Subject: Amendments to prior design modifications on the under-voltages protection systems. R. E. Ginna Nuclear Plant, Unit #1, Docket No. 50-244.

AMENDMENTS TO THE  
PROPOSED MODIFICATION ON  
THE LOSS OF VOLTAGE AND  
DEGRADE VOLTAGE PROTECTION SYSTEMS

R.E. GINNA STATION

FIGURE 2

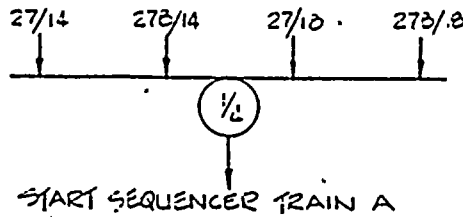
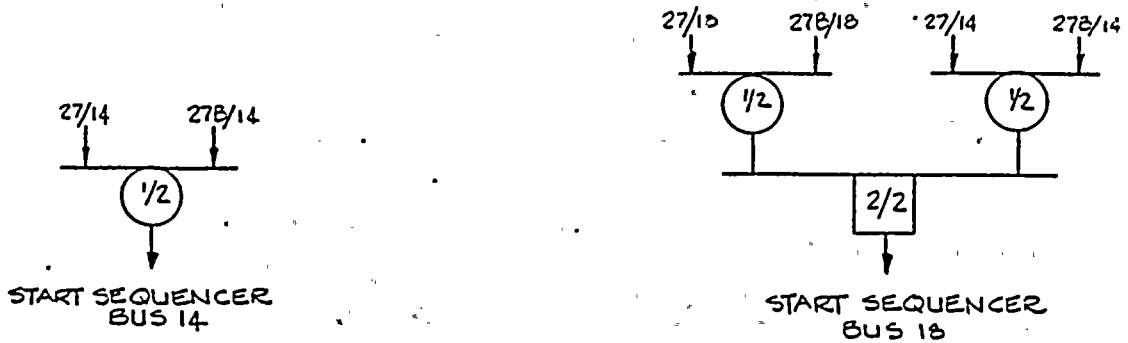
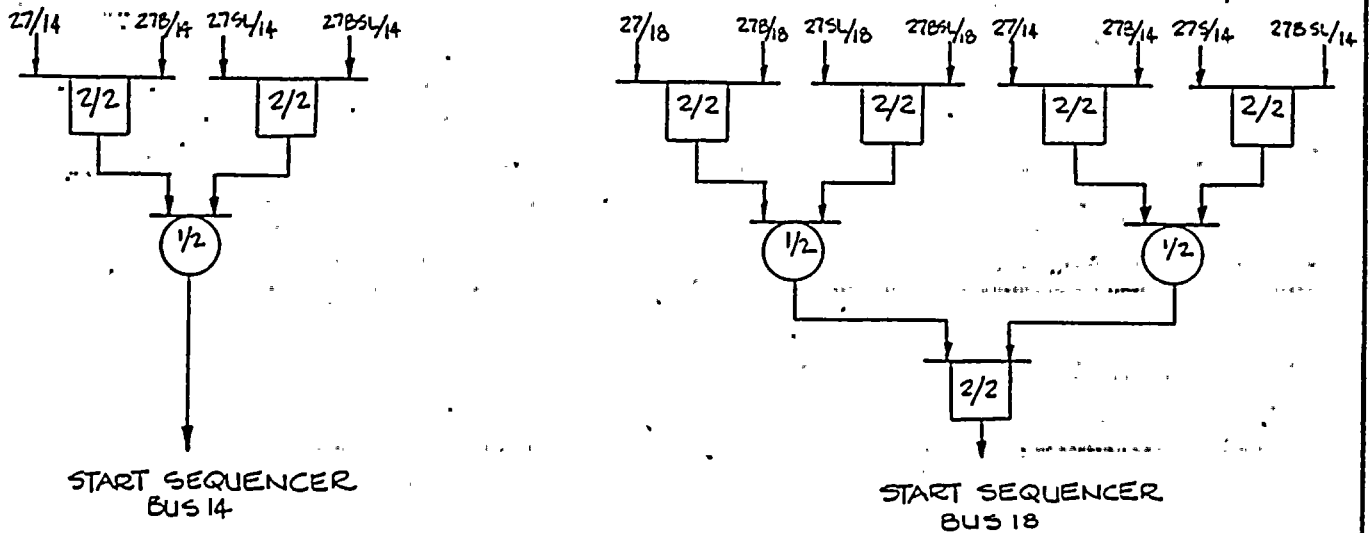
Figure 2 shows three different undervoltage logic schemes that will allow the sequencer to start. That is, the re-setting of the various undervoltage relays coincident with Safety Injection will start the timing train of the load sequencer.

Scheme 1 shows the existing 1 out of 4 logic required to start the sequencer. This is a reliable starting logic, however, there exists a low probability potential for relay timing differences that lead to lock out problems.

Scheme 2 is the proposed scheme discussed in reference 2. It mitigates most of the potential lock out problems without sacrificing the existing reliability. However, this scheme will be superseded by the same coincident logic used in the trip circuits.

Scheme 3 is the second level modification with coincident logic.

FIGURE 3

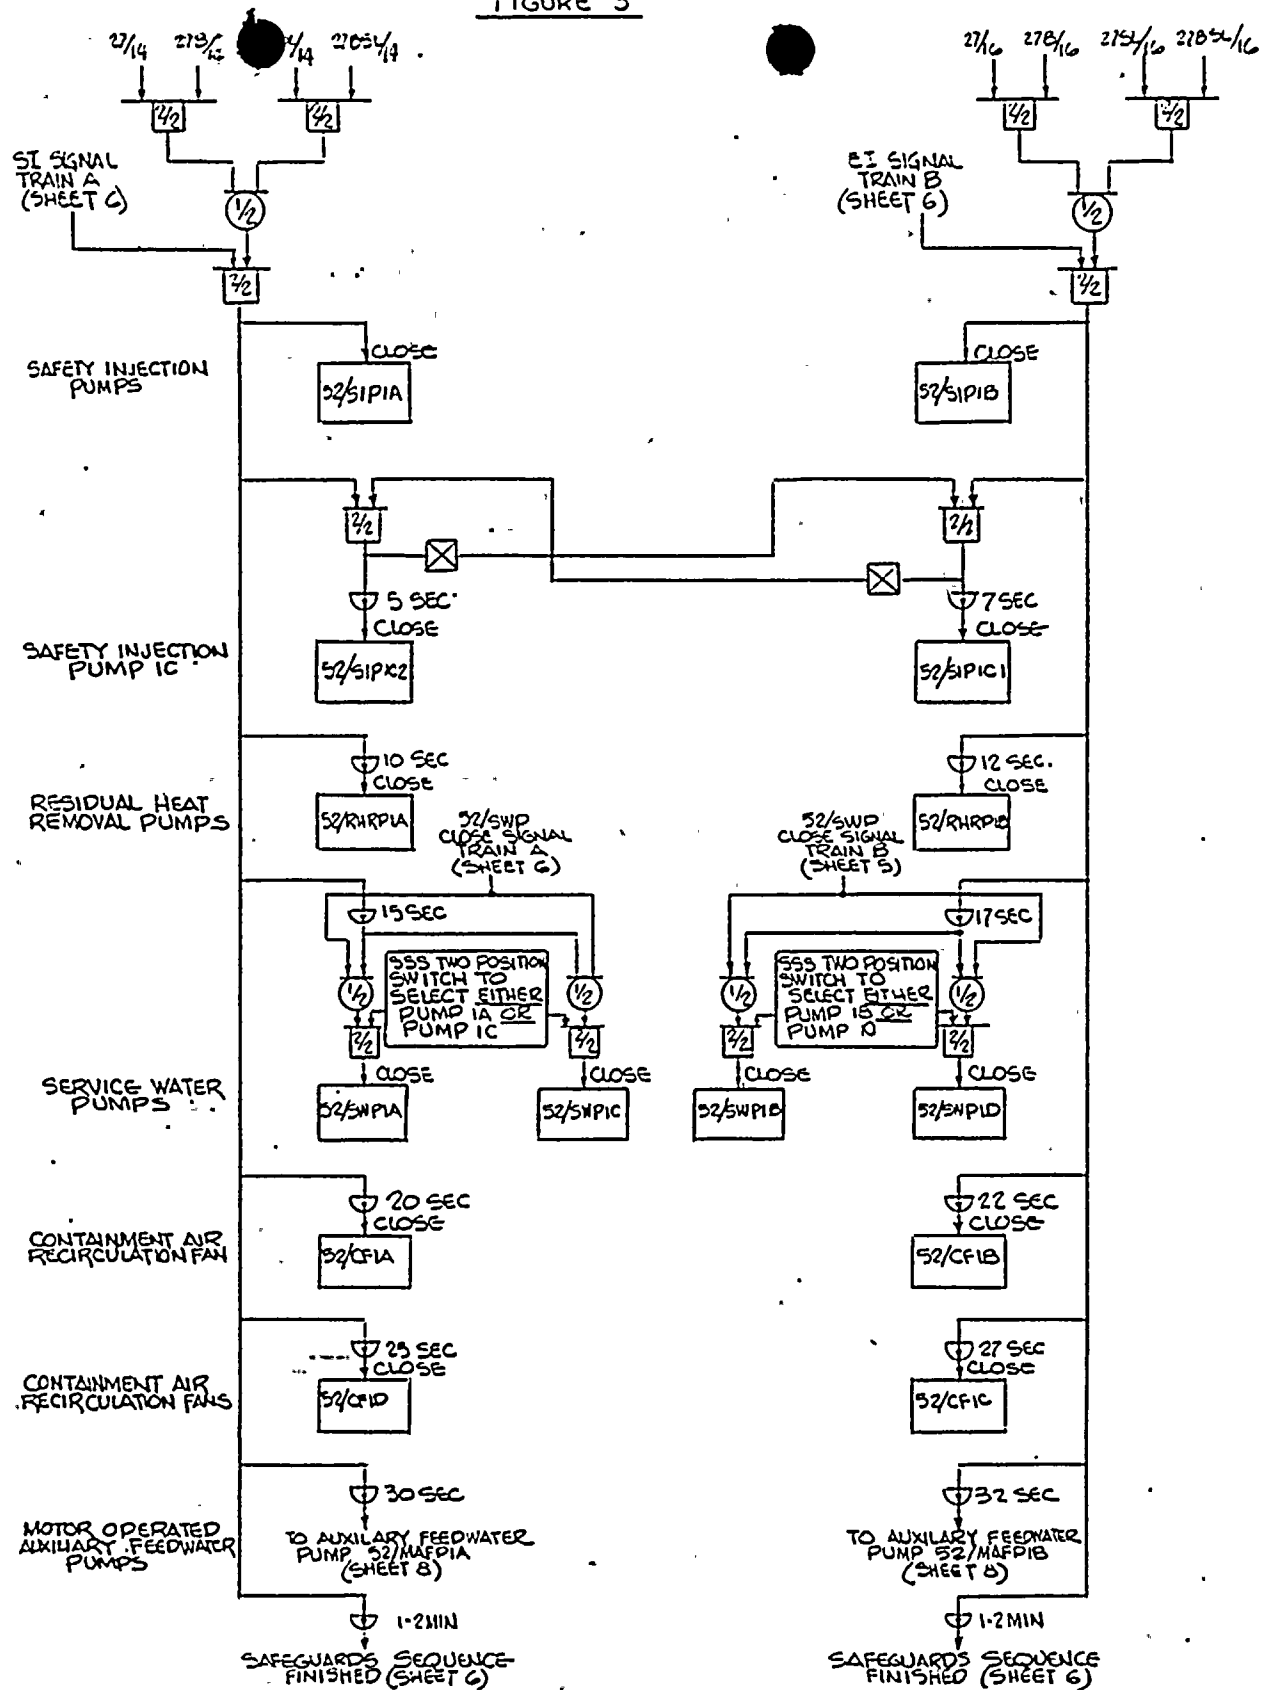
With the addition of the second level undervoltage relays, the reliability of sequencer starting using only buses 14 (or 16) will be at least equal to that of the existing system using buses 14 (or 16) and 18 or (17). Thus the new design can be simplified by using only bus 14 relays to start train A and bus 16 relay to start train B. The final sequencer logic is shown on figure 3.
